# Access Compliance Report

## Public Rights-of-Way

Intersection ID: 21910	Main Street: CARMEL_RD	Cross Street: COLONY_RD	Location: N
ADA ID: 4879808336EC	Ramp Type: PerpDiag	Initial Pass/Fail: Fail	Overall Compliance: No
Severity Score: 33.75			
Codes/Mitigation Info/Possible Solution		Field Measurements/Component Compliance

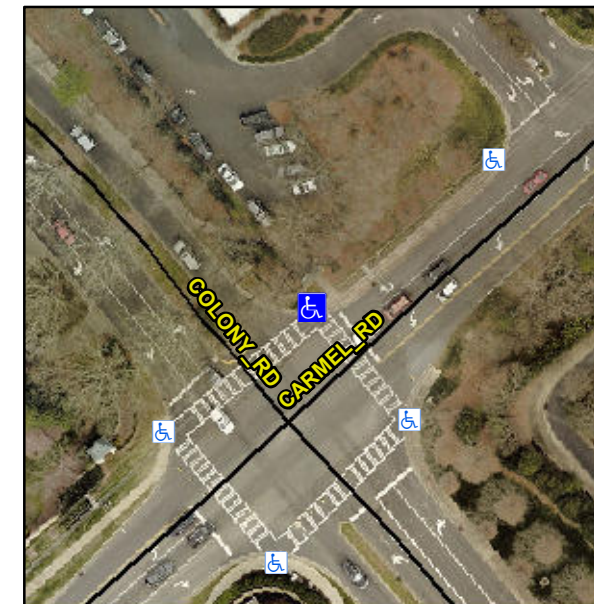
**Not Found, R304.5.1, R304.2.2**

Compliance	Description	Data	Compliance	Description	Data
N/A	Ramp Length (in)	60.0	No	Ramp Slope (%)	12.5
No	Ramp Width (in)	46.0	Yes	Ramp XSlope (%)	0.8
N/A	Flare Type LT	N/A	N/A	Flare Type RT	N/A
N/A	Flare Slope LT (%)	N/A	N/A	Flare Slope RT (%)	N/A
N/A	Flare Traversable LT?	N/A	N/A	Flare Traversable RT?	N/A
N/A	Landing Length (in)	N/A	N/A	DWS Provided?	N/A
N/A	Landing Width (in)	N/A	N/A	DWS Contrast?	N/A
N/A	Landing Slope (%)	N/A	N/A	DWS Length (in)	N/A
N/A	Landing X Slope (%)	N/A	N/A	DWS Full Width?	N/A
N/A	Landing Curb? (Y/N)	N/A	N/A	DWS Offset (in)	N/A
N/A	Shared Landing?	N/A			
N/A	Gutter Ponding?	N/A	N/A	Gutter Slope (%)	N/A
N/A	Gutter Lip Ht (in)	N/A	N/A	Gutter X Slope (%)	N/A
N/A	Painted X Walk1?	Yes	N/A	Painted X Walk2?	Yes
	X Walk 1 Direction	To SW		X Walk 2 Direction	To SE
N/A	X Walk 1 Width (in)	109.0	N/A	X Walk 2 Width (in)	101.0
	X Walk 1 Slope (%)	0.1		X Walk 2 Slope (%)	2.4
	X Walk 1 X Slope (%)	0.7		X Walk 2 X Slope (%)	0.2

**Remove & Replace Curb Ramp With Two New Directional Ramps or Equivalent.**
